DeKalb County Historic Preservation Commission

Staff Report

H. 1648 Ridgewood Drive, Adam Stillman. Construct an addition on the rear of a historic house, enclose a screen porch, widen driveway, and install landscaping and hardscape. **1248097**.

SITE PLAN (PROPOSED)

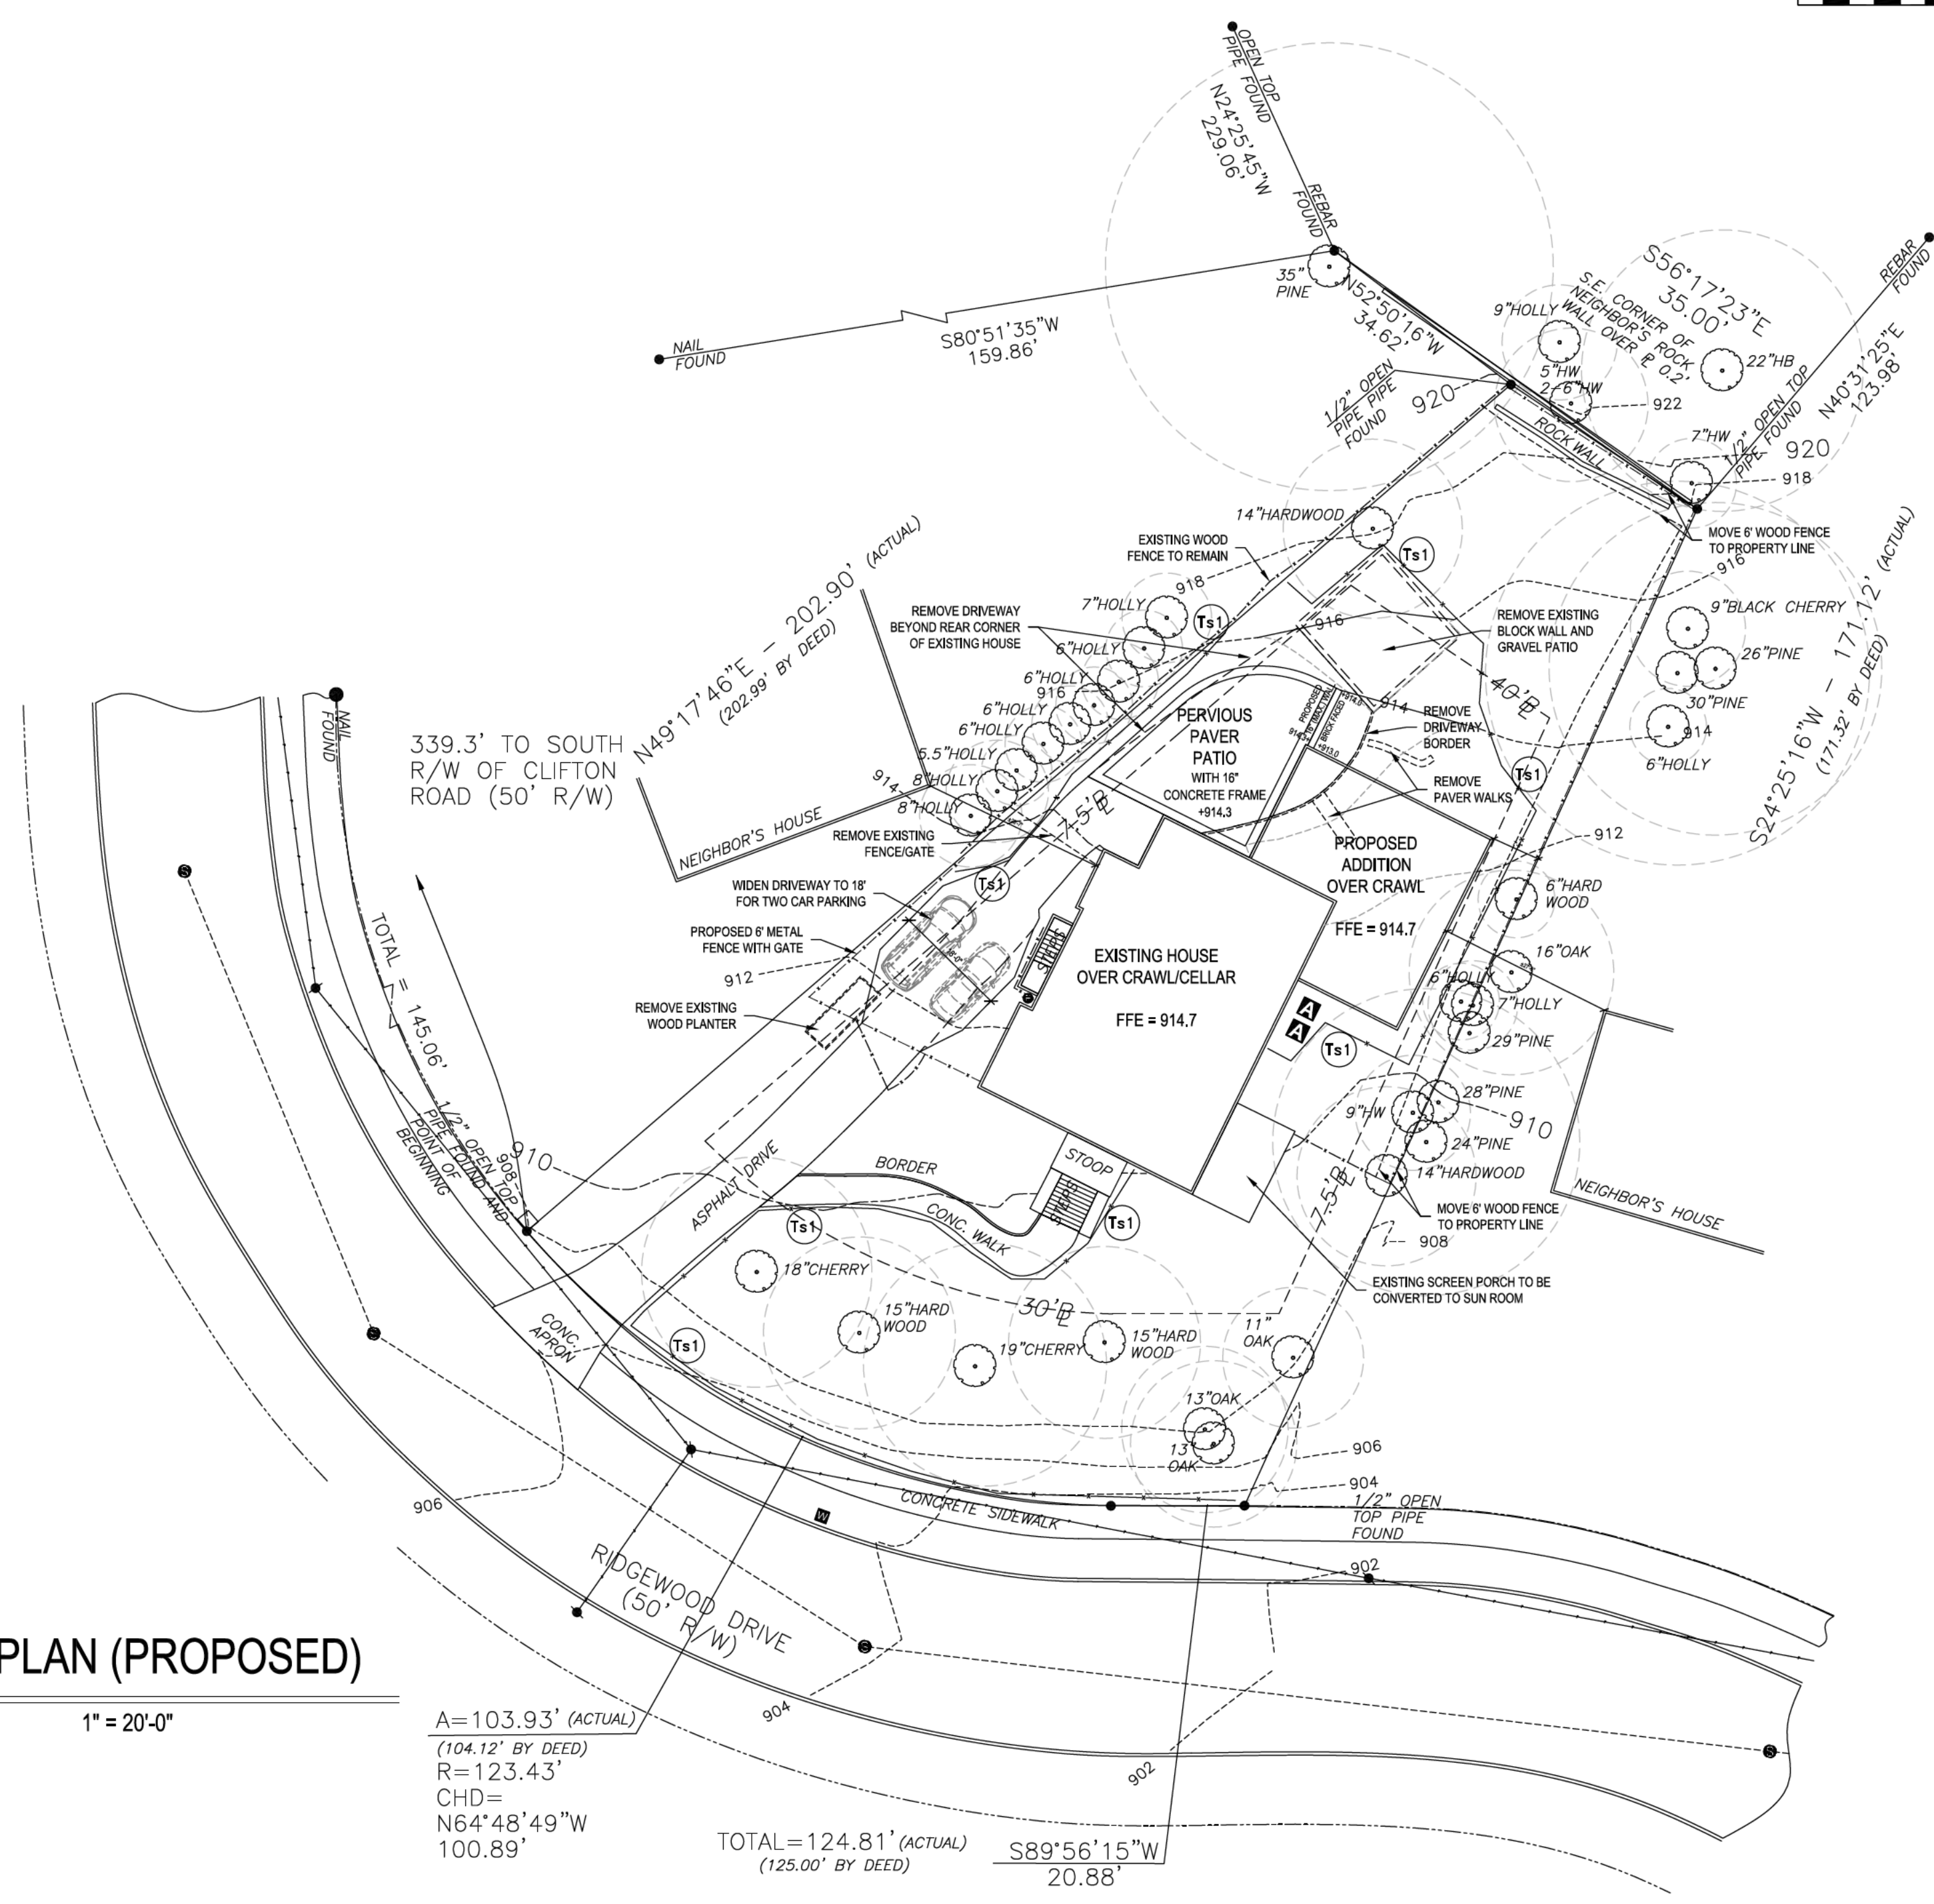
Guideline 6.1.3 and that the proposed fencing not extend beyond the rear corner of the historic house in accordance with Guideline 9.4.

PROPOSED
RIGHT ELEVATION

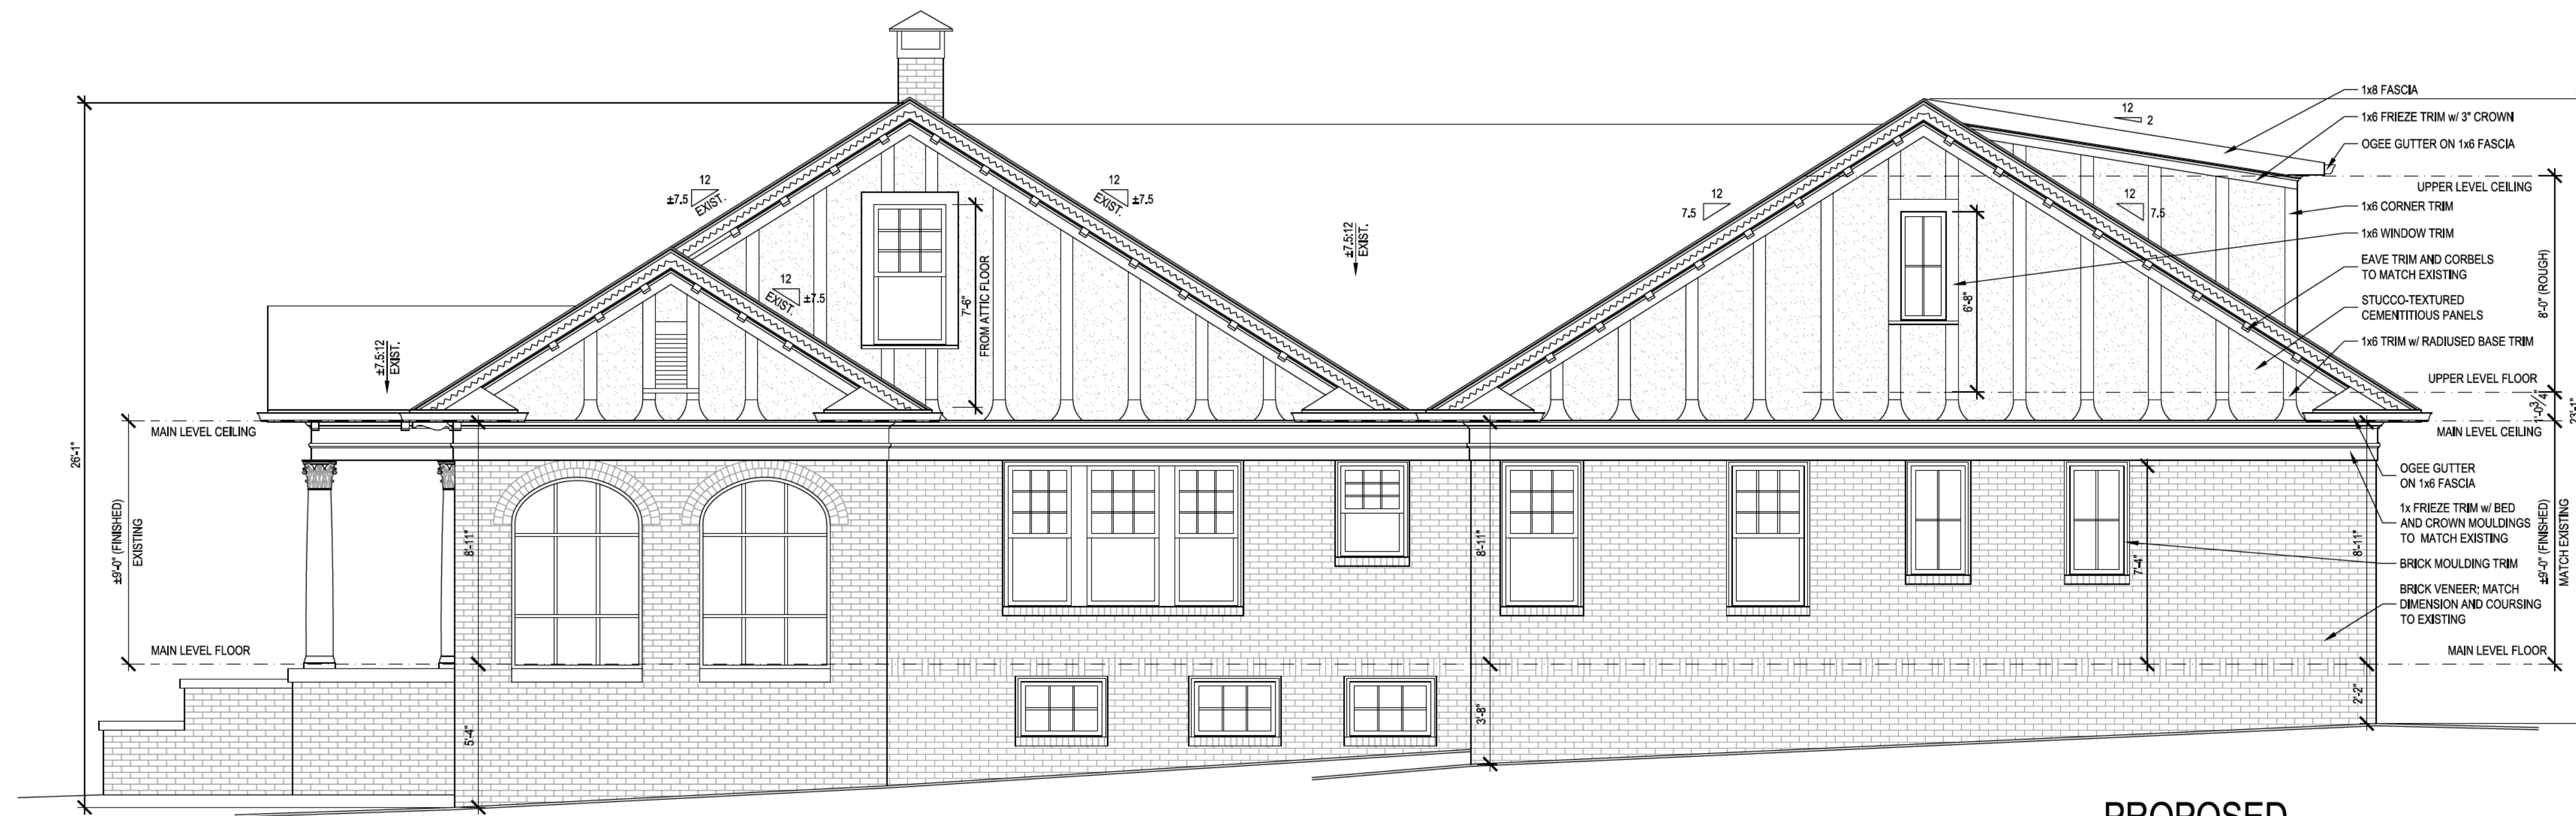
Approve with Modification. Staff recommends the approval of the proposed work with the modifications that the window placed in the front façade opening of the enclosed porch not include simulated dived lites in order to maintain the transparency of the opening in accordance with
